PROPOSED WAWANOSH DRAIN WIDENING  
HIGHWAY 7, SARNIA, ONTARIO  
W.P. 189-62

Re: Allowable Bearing Value,  
Proposed Wawanosh Drain Widening,  
Highway #7,  
Sarnia, Ontario.

SOIL CONDITIONS AND FOUNDATIONS  
PROPOSED WAWANOSH DRAIN WIDENING  
HIGHWAY NO. 7

W. P. 189-62

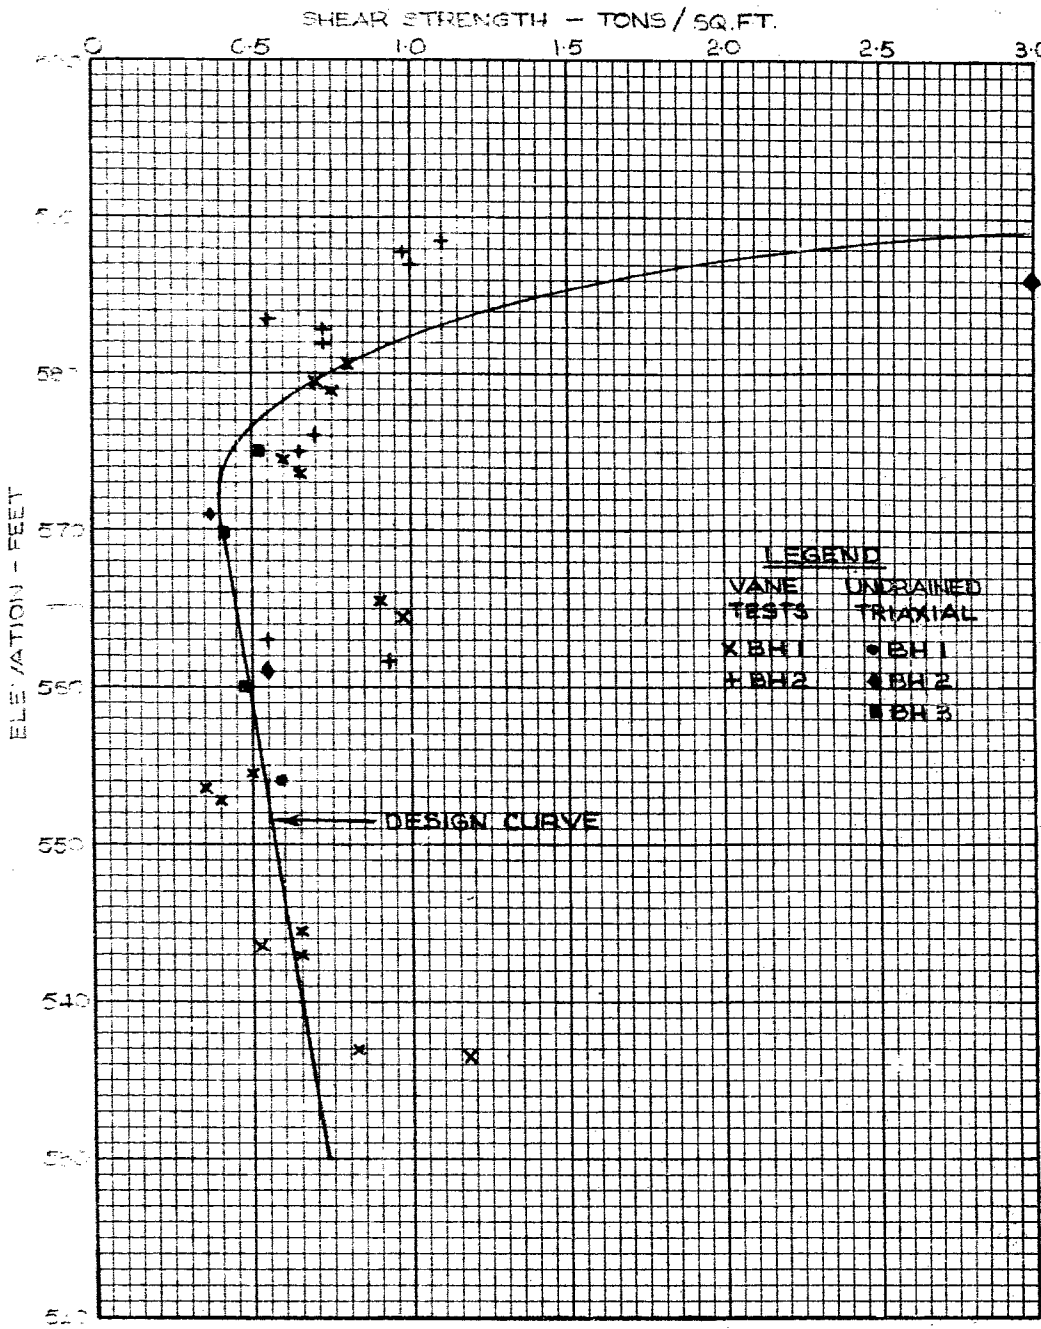
I had, before this meeting, checked on our calculations of strength from the field and laboratory data, and found no errors in interpretation. Based on this, we believe that the strengths as plotted on Figure 3 of Appendix II are correct. However, a slightly higher design curve may be inferred from these results in the region of the footing elevation, i.e. elevation 576.

Therefore, the allowable bearing value may be taken as 1.8 tons per square foot where dead plus live load is considered and 1.2 tons per square foot where dead load only is considered. These values are based on a design shear strength of 0.6 tons per square foot.
